ADDENDUM NO. I

SUBJECT: Addendum No. 1 – Hockey Netting System

Re: Roof Framing Evaluation for Rigging Loads
Knoxville Coliseum Roof Framing Evaluation and Scoreboard Relocation
Knoxville, Tennessee
CWE Project No. 2009145.00

Photo 1 – Sample Sketch of Concrete Frame Cracking at Fixed end of Cantilever
(actual cracks have been painted over and are not visible in this photo)

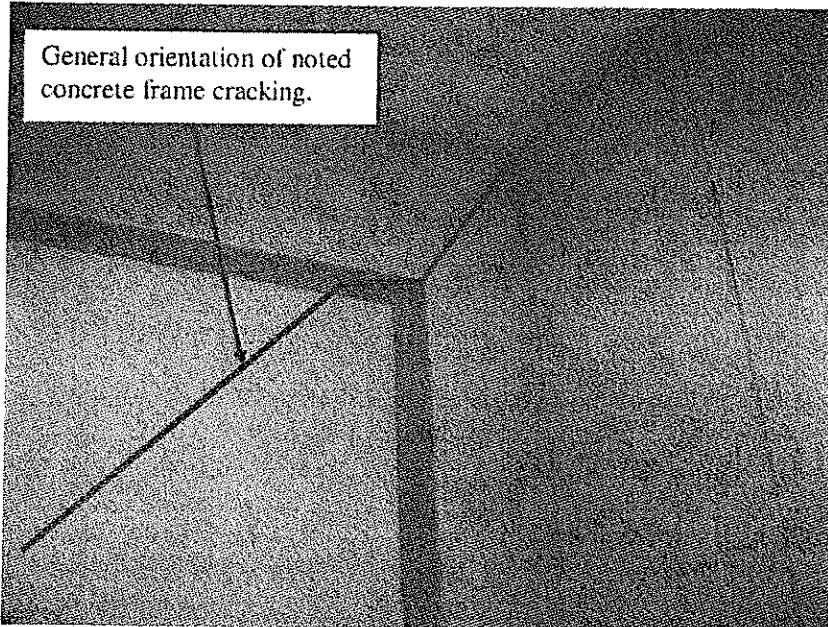
During our initial walk-thru, it was noted that the cantilever concrete frames which support the steel arch section of the roof had visible cracking as seen in photos 1 and 2. The exact extent of the cracking was partially masked by the painting conducted a few years ago. These cracks appear to have been present for a relatively long period of time. Coliseum personnel were not aware of their existence, and painting contractors had not brought it to their attention. These cracks appear to be fairly tight with no evidence of recent significant movement. However, given their critical location within primary framing members that possess no redundancy, we recommend that these cracks be closely monitored. We are available to assist in the development of a system and schedule for the monitoring and recording of any movements. We recommend cracks be monitored for a minimum period of a year. Readings should be recorded on a monthly cycle, after the application of rigging loads from each significant event/show, and during each significant snow occurrence. If significant movement occurs, these cracks should be further evaluated. Alternatively, CWE can provide the monitoring of cracks on an hourly rate or negotiated basis.

INTERMEDIATE TRUSS PROFILE

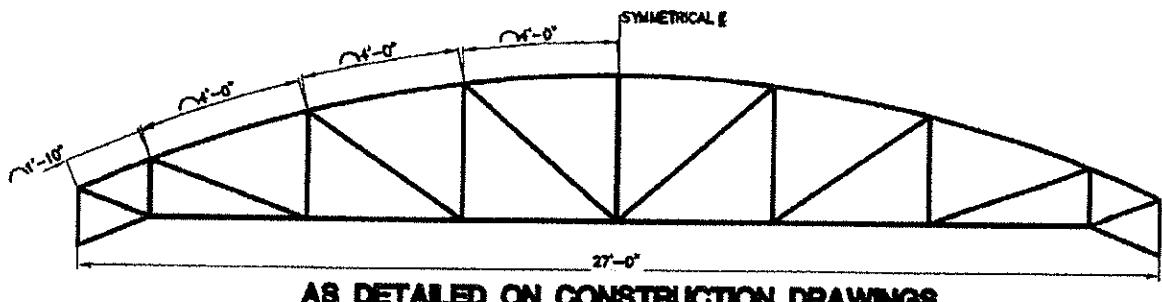
were randomly verified with that shown on the original structural construction drawings. A significant deviation in the web member layout of the conventional steel trusses was observed and noted. Refer to the attached Intermediate Truss Profile sketch depicting the observed deviation. Our computer analysis model was adjusted accordingly, and based on our results, it is our opinion that the actual layout does not adversely affect the intended structural performance of these trusses.

ATTACHMENT #1
PREVIOUS RIGGING GUIDELINES

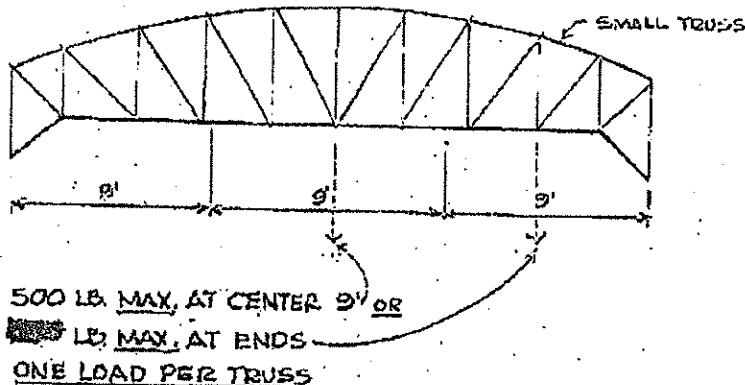
1500 LB. MAX. EACH LOAD
AT LEAST 8' BETWEEN LOADS
(1500 LB. INCLUDES LOADS FROM TRUSSES)

DO NOT SUSPEND LOADS FROM ROOF DURING SNOW, RAIN OR HIGH WIND

PROJECT Knoxville Civic Coliseum NO. 2008145.00
COMPUTED BY MRR DATE 11/30/11 CHECKED BY DATE
SUBJECT Allowable Steel Arch Loading Profiles SHT 9 OF 11

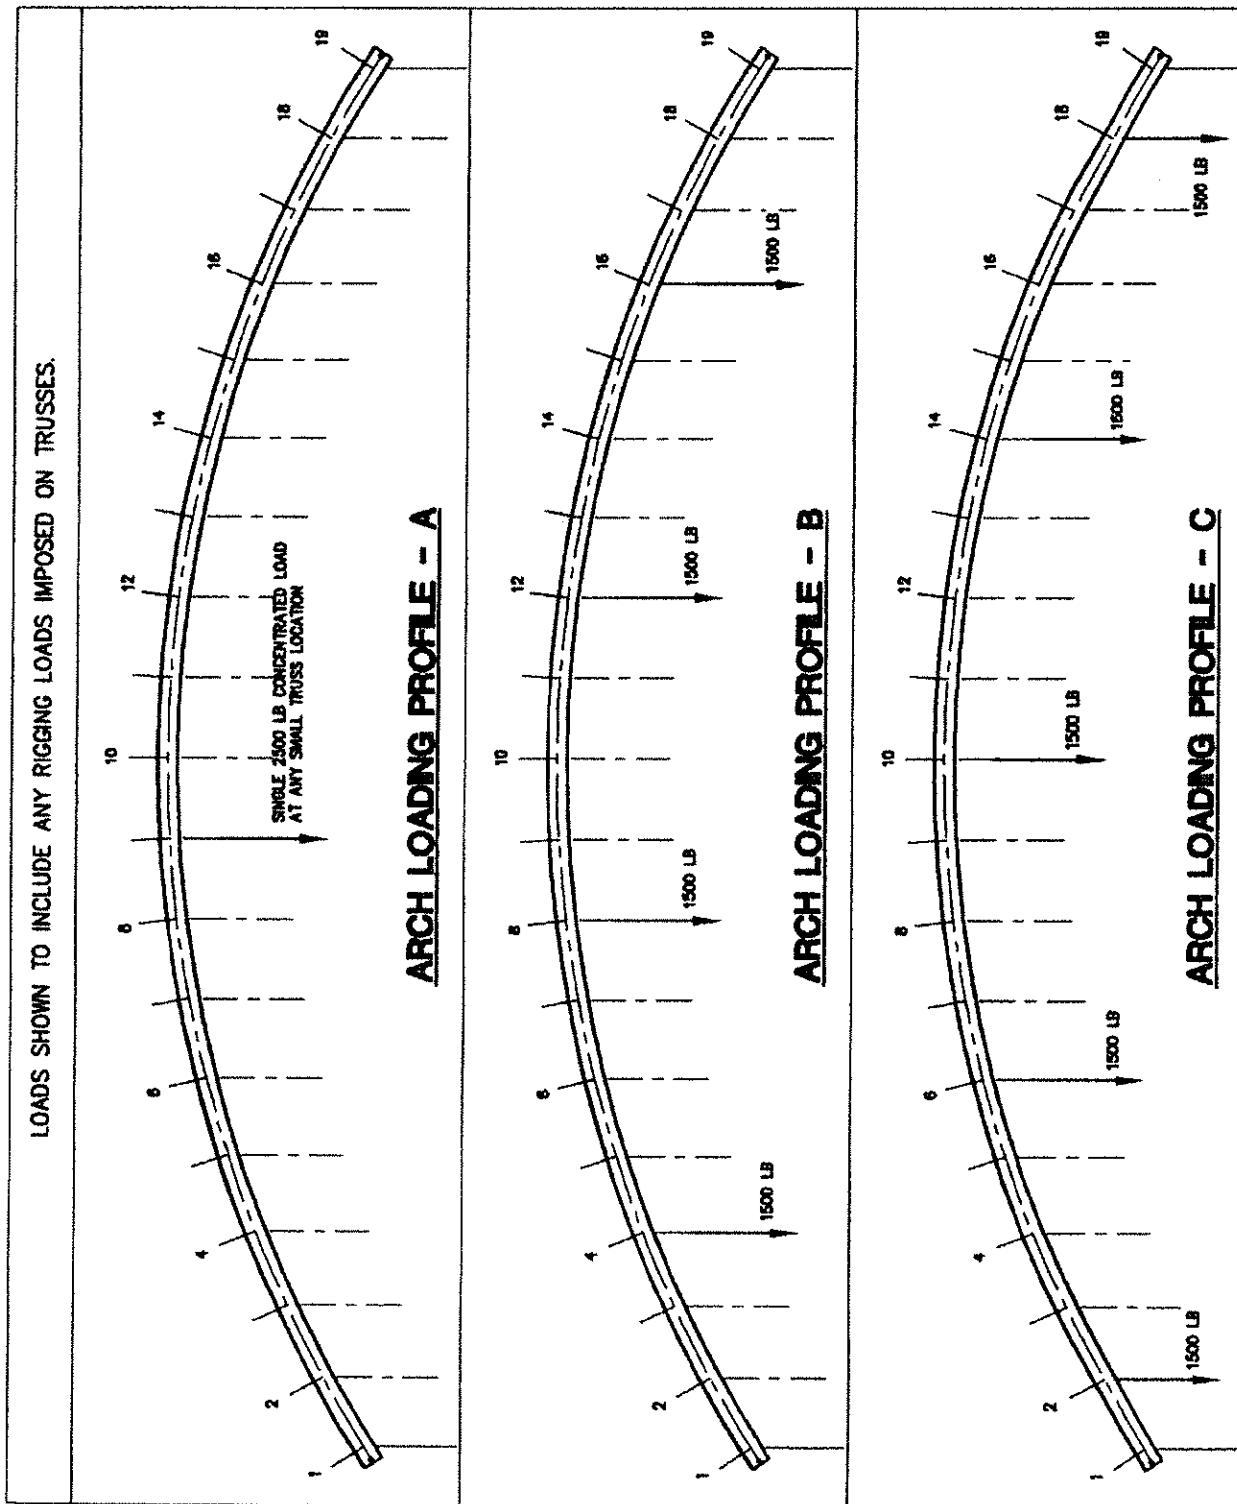
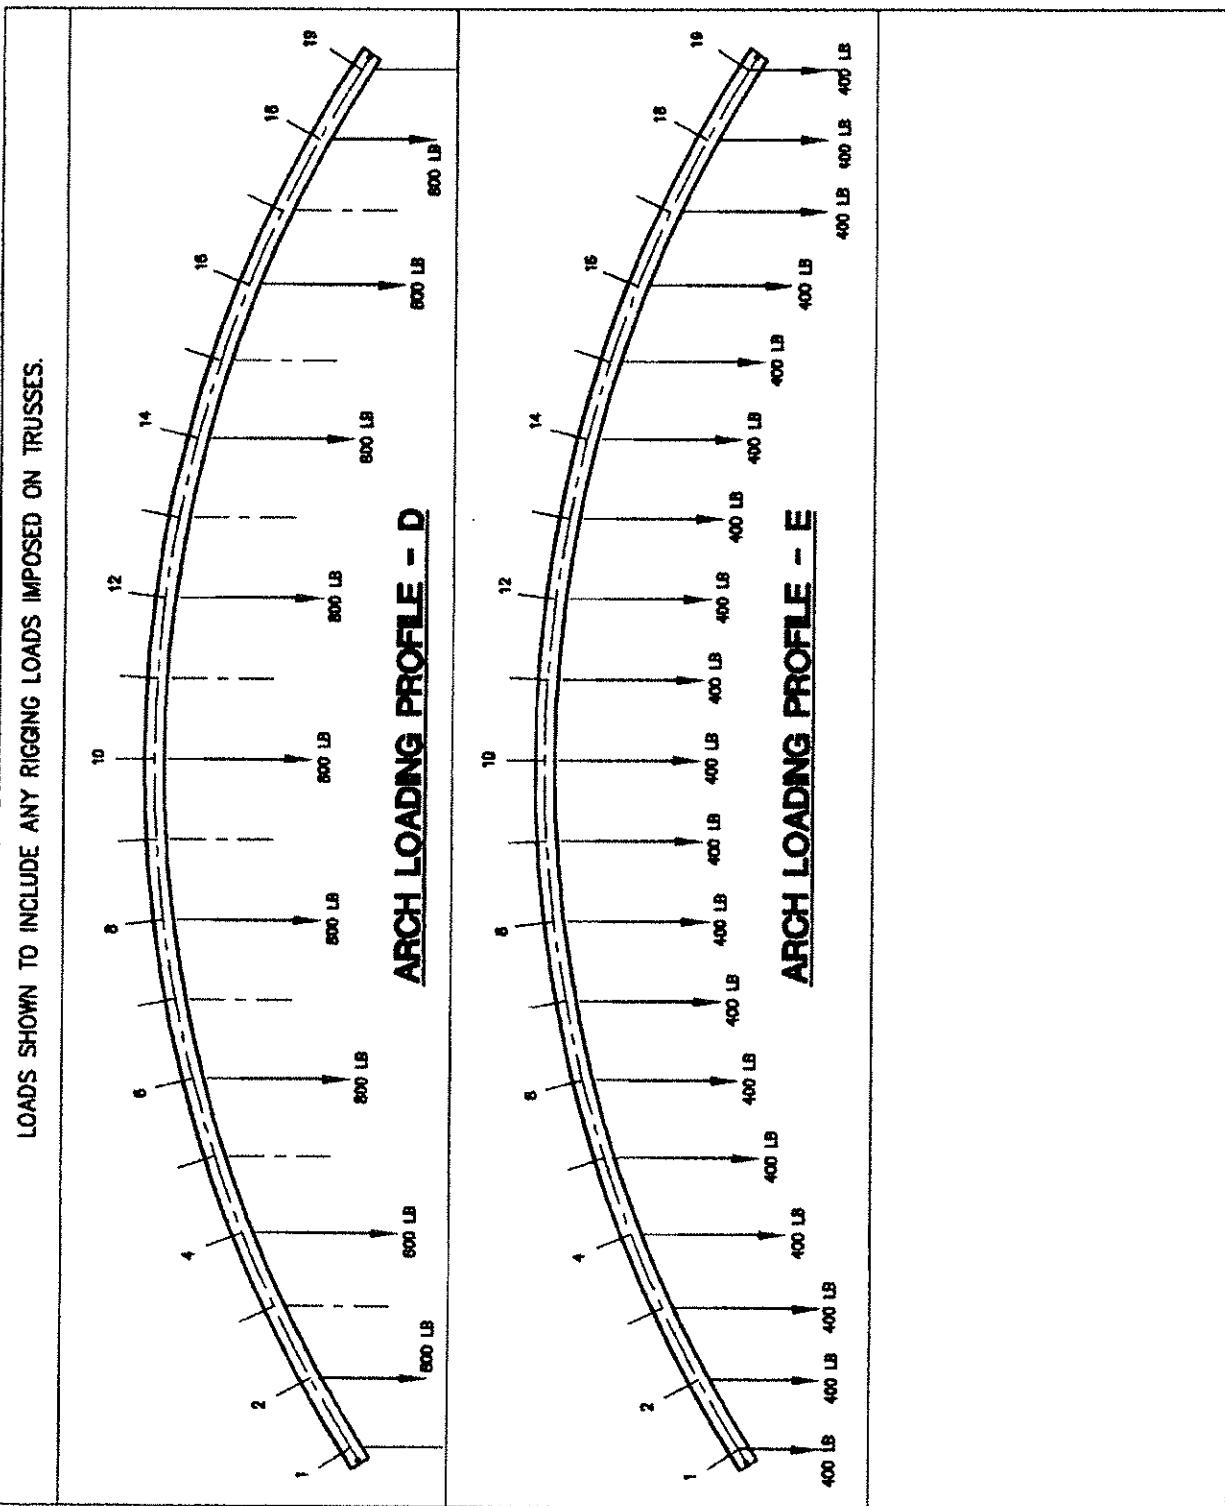
- A single suspended load of up to 2500lb applied directly to the arch at one small truss location.
 - "Arch Loading Profile - A".
- Four or five suspended loads of no more than 1500lb applied directly to the arch at every fourth small truss location.
 - "Arch Loading Profile - B" OR
 - "Arch Loading Profile - C".
- Multiple suspended loads of no more than 800lb applied directly to the arch at every other small truss location.
 - "Arch Loading Profile - D"

- Multiple suspended loads of no more than 400lb applied directly to the arch at every small truss location.
 - "Arch Loading Profile - E"

ROOF TRUSS LOADING PROFILE - F

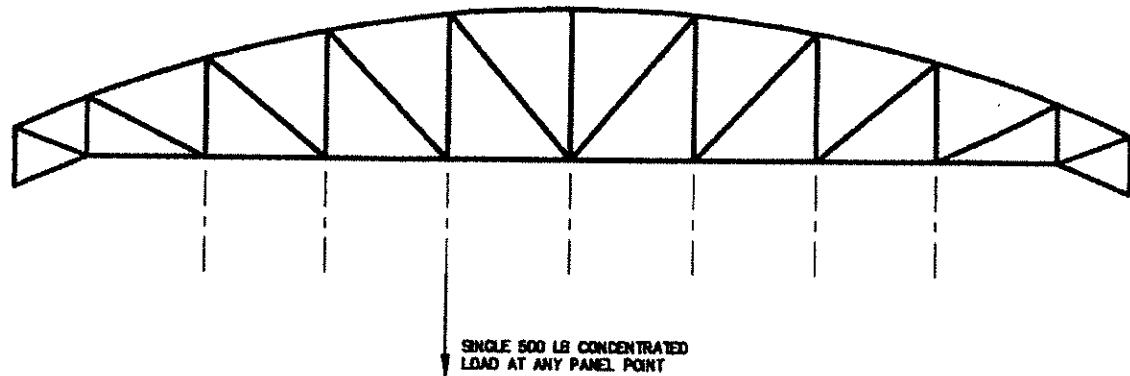
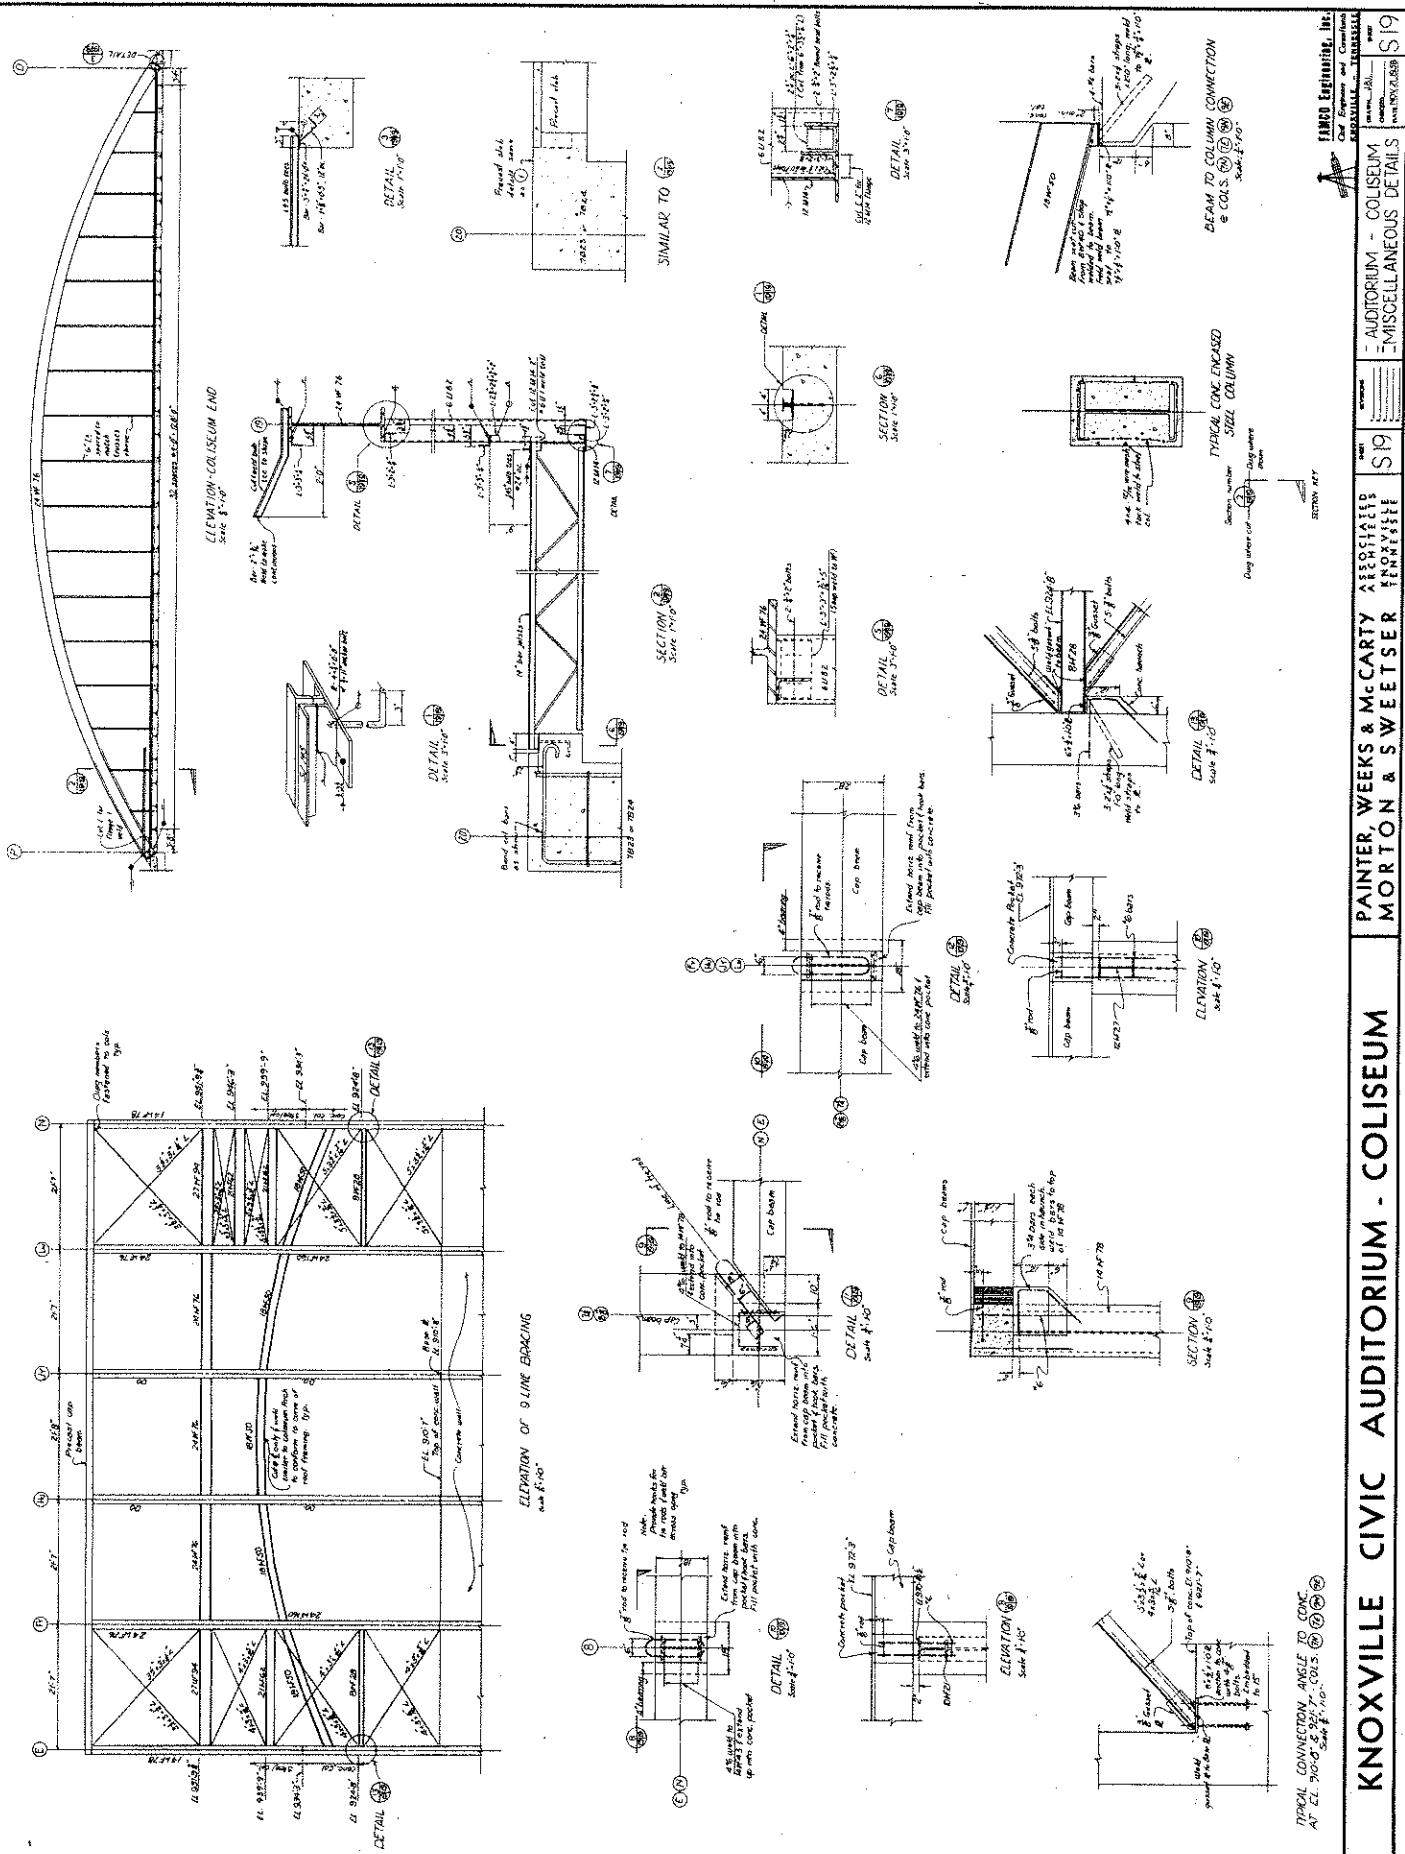
For the typical roof trusses, a maximum single load of 500 lb may be applied at any panel point. Do not hang loads greater than 6" away from panel points that would produce bending in the bottom chords. Refer to Roof Truss Loading Profile - F attached.

DO NOT APPLY CONCENTRATED LOADS BETWEEN PANEL POINTS THAT WILL PRODUCE BENDING OF TRUSS CHORDS.
